DENVER AMENDMENT PROPOSAL FORM FOR PROPOSALS TO THE 2019 DENVER BUILDING CODE AMENDMENTS AND THE 2021 INTERNATIONAL CODES

2021 CODE DEVELOPMENT CYCLE

R401.2.5

Model and Local Denver Energy Code Performance Trajectory

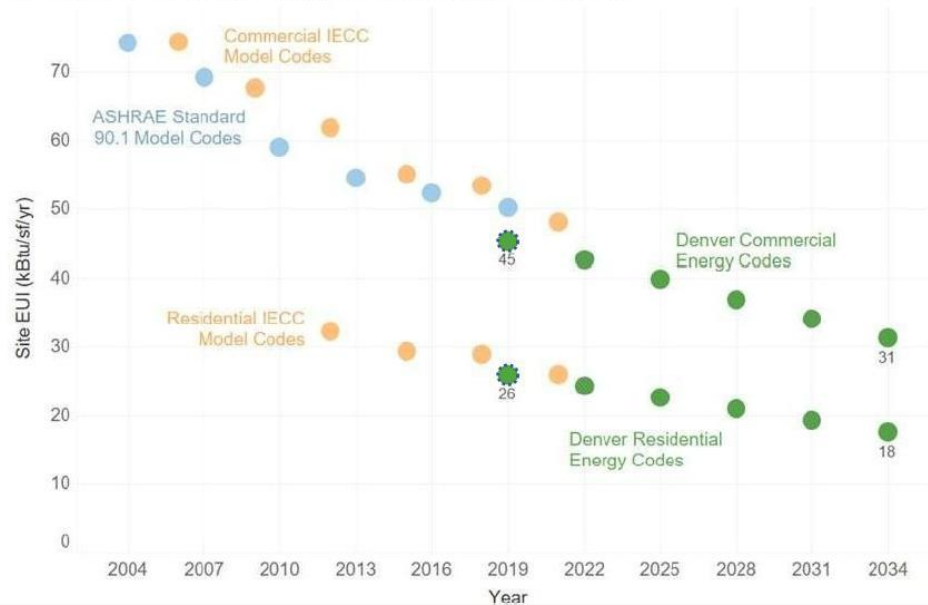
“Denver’s Net Zero Energy (NZE) New Buildings & Homes Implementation Plan” sets a goal for all new Denver homes to achieve zero energy by the 2024 code cycle. Achieving this goal will require that the 2021 Denver Energy Code achieve 15% savings compared to the 2021 IECC. There are multiple energy efficiency measures that could be added to the Denver Energy Code that can deliver the significant savings required to meet this goal. However, some of these measures may not be cost effective for, or compatible with, all home designs. This issue was addressed in the commercial section of the code with the conversion of the additional efficiency options in Section C406 to a credit-based system. The credit-based system allows projects to select the most effective and appropriate measures to achieve the performance goal of the code. This maximizes flexibility while still allowing the code to achieve higher levels of performance.
